Response to recommendations and questions from the MICE Project Board

MICE collaboration

MPB4 October 2012

Figure 2 Provisional MICE schedule as of October 2012

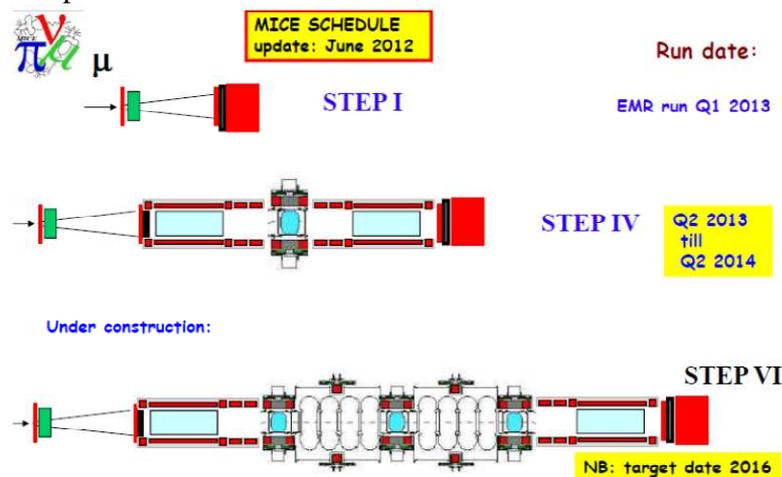
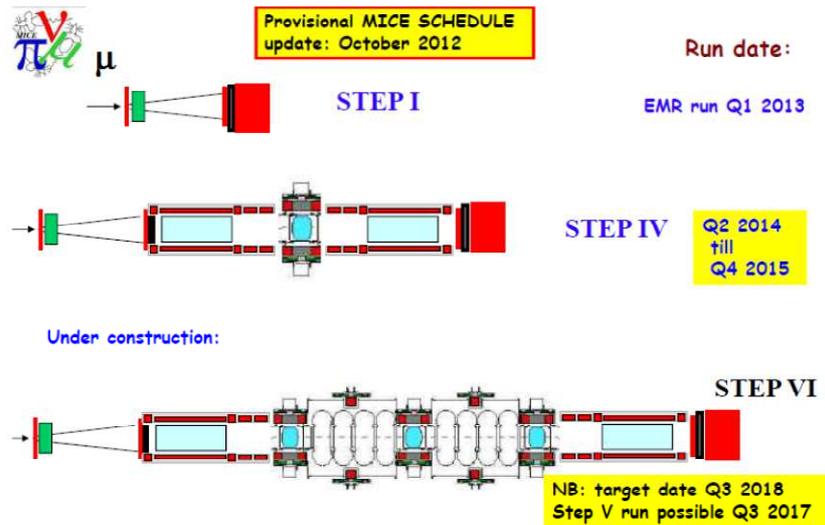
4. Make a single integrated resource loaded schedule for the production, assembly, installation and commissioning of all components, and present at the next MPB. Link this schedule with the available budget.

The full Microsoft project file can be found in [2]. The MICE schedule sketch as it was on June 2012 is shown in Figure 1. The new schedule is shown on Figure 2. Step IV run date is shifted by one year and step VI by two years. The analysis of the main delays is given below. The driving items remain construction and commissioning of the spectrometer solenoids for step IV and coupling coils for step VI, but the need to provide adequate magnetic shielding for the support equipment (power supplies, compressors, electronics, etc..) presently in the MICE hall would have added an incompressible element to the schedule if it had not been for the magnet delays.
